City of Portland, Maine – Building or Use Permit Application 389 Congress Street, 04101, Tel: (207) 874-8703, FAX: 874-8716

Location of Construction: 116 Ledgewood Road Peaks Island		Owner: **Richard P. Caron		Phone: 766-5084		Permit No: 991164	
Owner Address: **P.O. Box 101 Peaks Island, ME 04108		Lessee/Buyer's Name:		Phone:		BusinessName:	
Contractor Name: Owner/Builder		Address:		Phone:		Permit Issued: OCT 26 1999	
Past Use: Vacant		Proposed Use: New Single Family		COST OF WORK: \$ 40,000		PERMIT FEE: \$ 264.00	
				FIRE DEPT. <input type="checkbox"/> Approved <input type="checkbox"/> Denied		INSPECTION: Use Group: A-3 Type: 5B BOCA 96	
Proposed Project Description: New Single Family dwelling - new construction - wood frame.		Signature:		Signature: <i>[Signature]</i>		Date:	
Permit Taken By: SP		Date Applied For: 9-2-99		PEDESTRIAN ACTIVITIES DISTRICT (P.A.D.) Action: <input type="checkbox"/> Approved <input type="checkbox"/> Approved with Conditions <input type="checkbox"/> Denied		Zoning Approval: OK w/ TR conditions 9/27/99 Special Zone or Reviews: <input type="checkbox"/> Shoreland N/A <input type="checkbox"/> Wetland <input type="checkbox"/> Flood Zone NA Zone C <input ty

DISPOSAL AREA CROSS SECTION

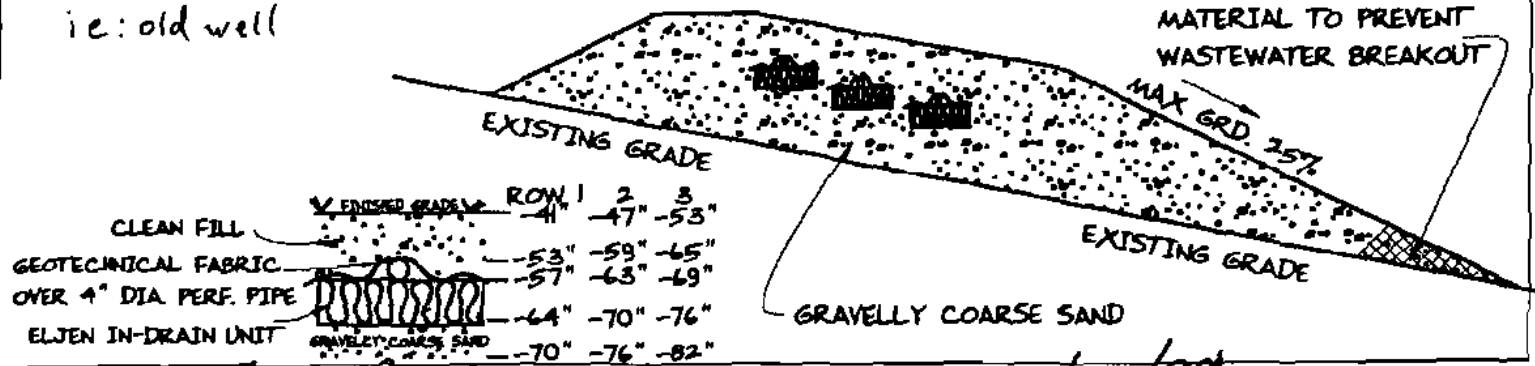
9-14-99 Talked to Joy Hardease!! state site evaluator and he said to just fill it with Bed Material, I relayed info to Rick Caron By phone 9-14-99 - 8:35 AM i.e.: old well
